# UNITED STATES PATENT AND TRADEMARK OFFICE

| APPLICATION NO. | FILING DATE | FIRST NAMED INVENTOR | ATTORNEY DOCKET NO. | CONFIRMATION NO. |
|-----------------|-------------|----------------------|---------------------|------------------|
| 10/756,379      | 01/14/2004  | Markku Kakko         | 1381-0308P          | 2365             |

**Office Action Summary**

FIG. 9

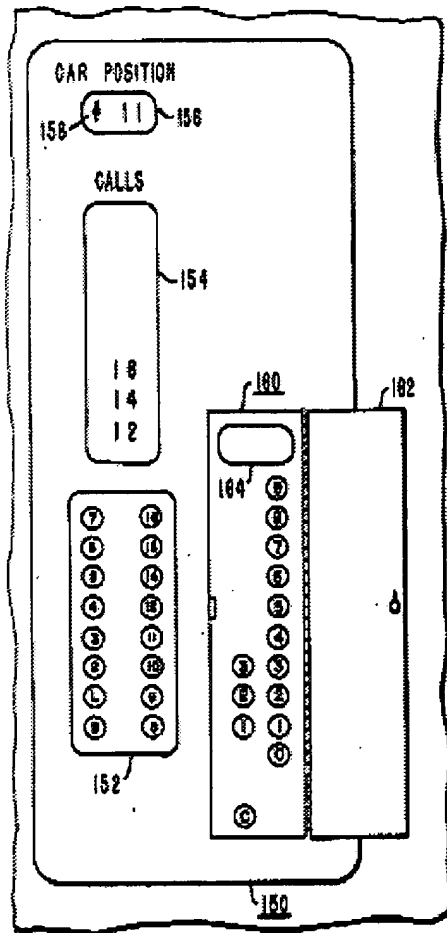
Mandel et al teaches in figures 1-10, an elevator display/operating system.

Destination floors 154,178 displayed in car and on floor.

Col. 1, lines 51-58 state display in order to be served in car and in order of associated floors in hall.
